Re: BusConnects Bray to City Centre Core Bus Corridor Scheme
Bray to Dublin City Centre.

BRAY TO CITY CENTRE CORE BUS CORRIDOR SCHEME

Strategic Infrastructure Development Application

Bord Pleanála Case reference: KA27.317780

Fig 1

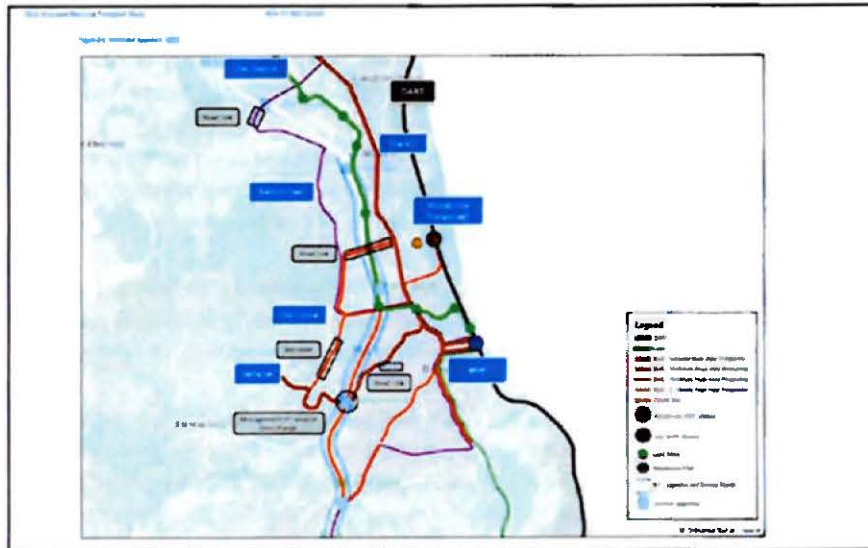
I wish to focus on Route Option 2A. I contend that Route 2A was never a viable option. The proposed alignment on the eastern side of the M11 coincides with the proposed alignment for the future extension of the Luas Green Line from Brides Glen to Bray, as set out in the Bray and Environs Transport Study 2019, see Fig 1. This alignment is confirmed in the Dun Laoghaire-Rathdown County Development Plan, see Fig 2.

Fig 3

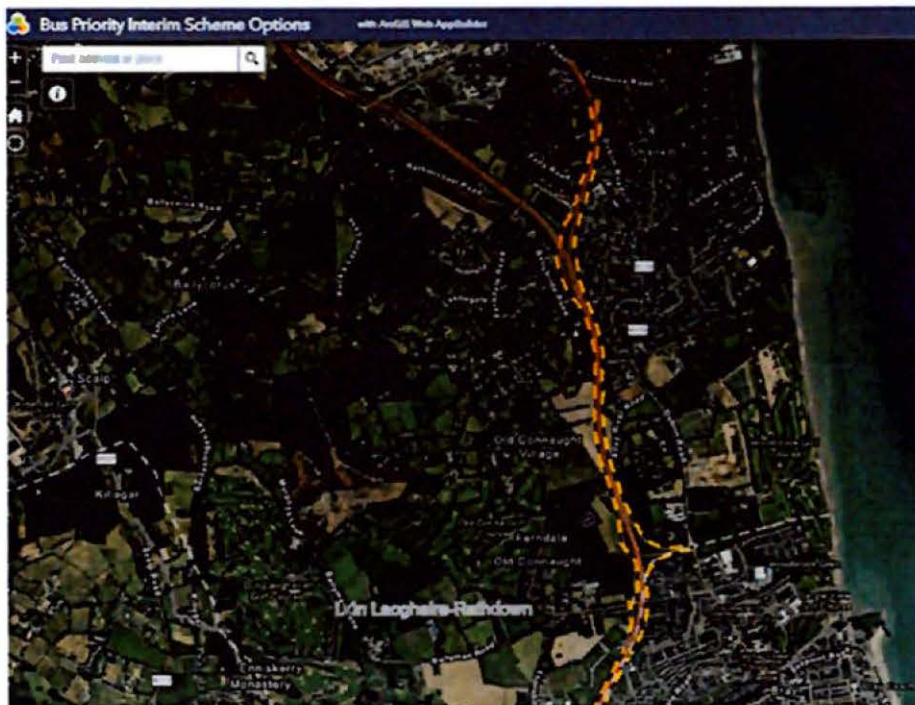
However, the link to Wicklow County Council's website [N11-M11-Bus Priority Interim Scheme](#) for the new proposed bus priority measures on the M11/N11 between Loughlinstown Roundabout and the Glen of the Downs demonstrates that bus priority measures on the M11/N11 corridor were in fact quite feasible. Drawings of the proposal are available on the website. A plan of the northern section, coinciding with Section 3 of the Bray to City Centre Core Bus Corridor is shown in Fig 3.

I am not advocating the removal or re-direction of bus services from Shankill; however, it appears that an Option that was summarily dismissed at Feasibility and Route Options Stage is now not just acceptable but is seeing the light of day and it would appear that the severe constraints identified at the time of the Feasibility and Options Report have been successfully overcome so as to allow priority bus measures to be accommodated within the motorway reservation in the section of the M11 between Loughlinstown Roundabout and Wilford Junction (Junction 5).

Fig 5

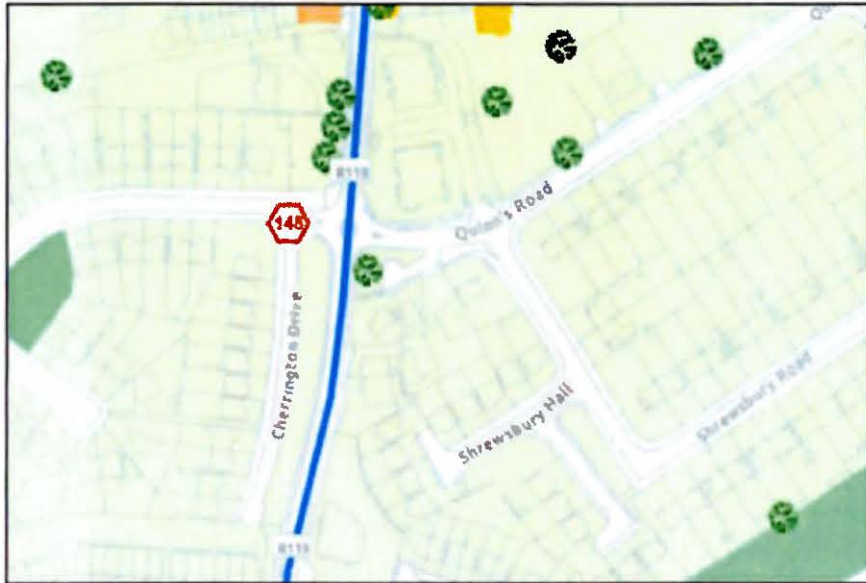
The proposed removal of the roundabouts at St. Anne's Church and at Quinns Road/Cherrington Road directly contravenes SLO 148 which is *"To protect and safeguard the roundabouts on the approaches into Shankill village at St. Anne's Church and at the junction of Dublin Road (R119) and Quinn's Road."*, see Figs 4 & 5.

Fig 8

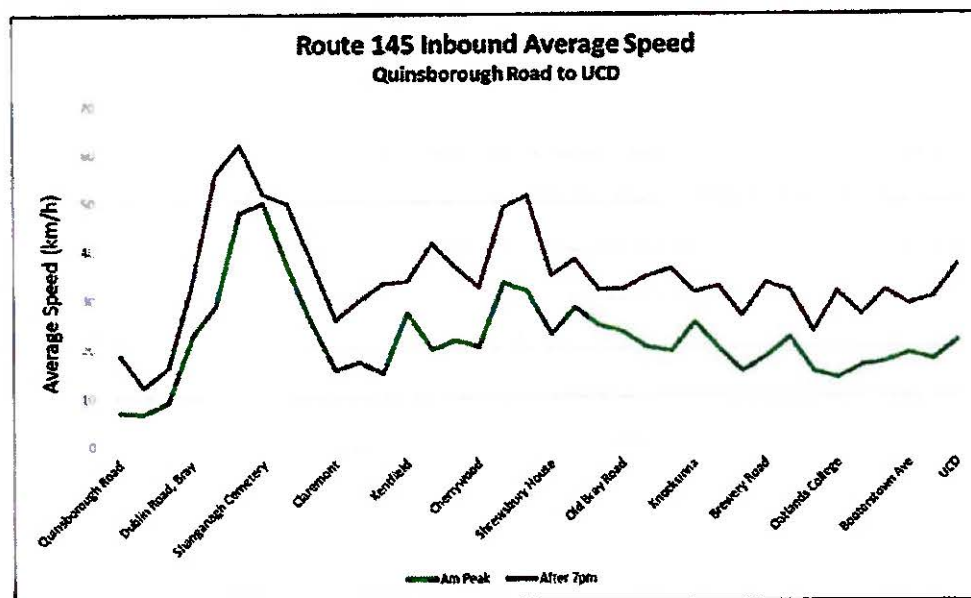
Of particular note is the journey time profile between Shankill Village and Wilford. Inbound, (Fig 8), journey peak time bus speeds are 50km/h in the am peak, but reducing at Claremont at the southern edge of Shankill Village. Off-peak after 7pm, the average speed is marginally over 60 km/h, again dropping on the immediate approach to Shankill village. The speed limit on this section of road is 50km/h. So at peak times, average bus speed matches the speed limit.

Fig 9

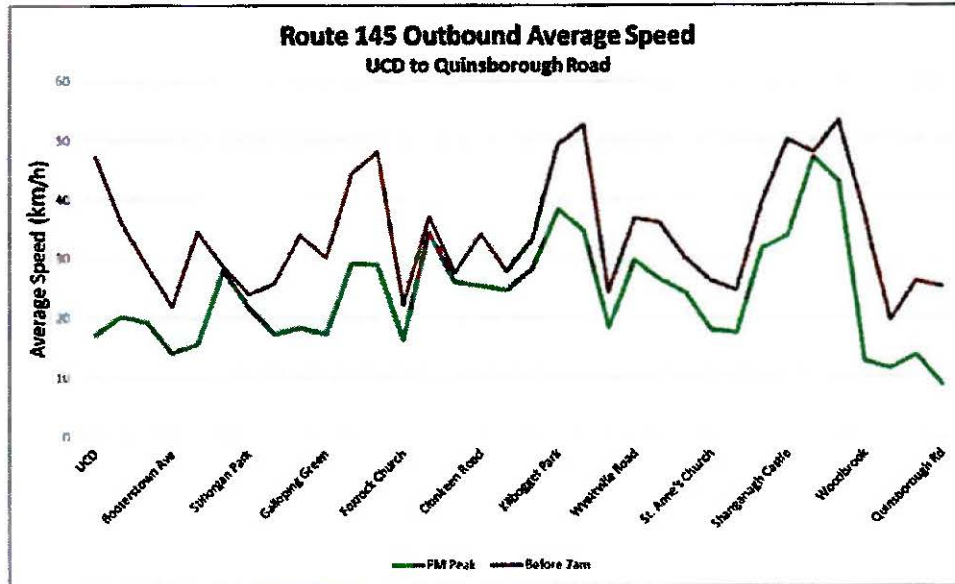
Outbound presents a similar profile – but in reverse, (Fig 9). Southbound bus speeds, both peak and off peak, increase at Shankill Village, rising to approximately 46km/h between the village and Wilford in the pm peak and to 54 km/h before 7am.

Fig 10

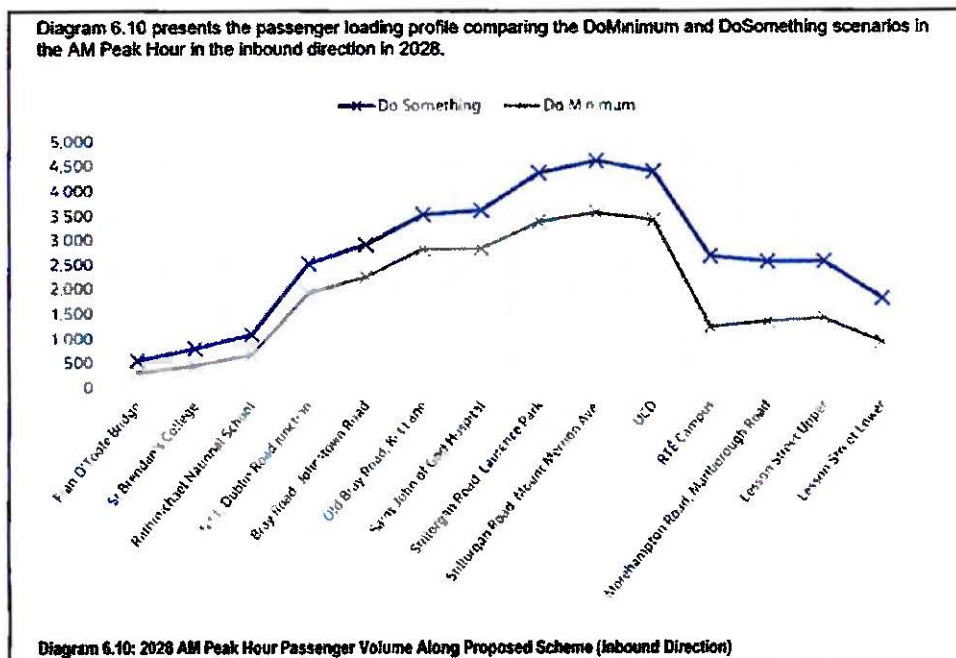
- a) It is clear from Fig 10 that Section 3 and Section 4 of the scheme coinciding with Shankill and environs has the lowest Peak Hour passenger volumes of any section of the scheme and the lowest absolute increase in passenger numbers between the Do Minimum and Do Something Scenarios,
- b) Fig 11 demonstrates that the time savings as modelled would appear to be very modest along the 3.3km section from Wilford to Loughlinstown Roundabouts – Chainages approximately 1,100 to 4,400 – 2028 Scenario – Inbound AM Peak'
- c) Fig 12 shows that for the outbound PM Scenario, the Do Minimum and Do Something lines are parallel along the sections of route coinciding with Loughlinstown to Wilford Roundabouts – indicating that little or no journey time benefit is being derived along this section arising from the Do Something intervention.
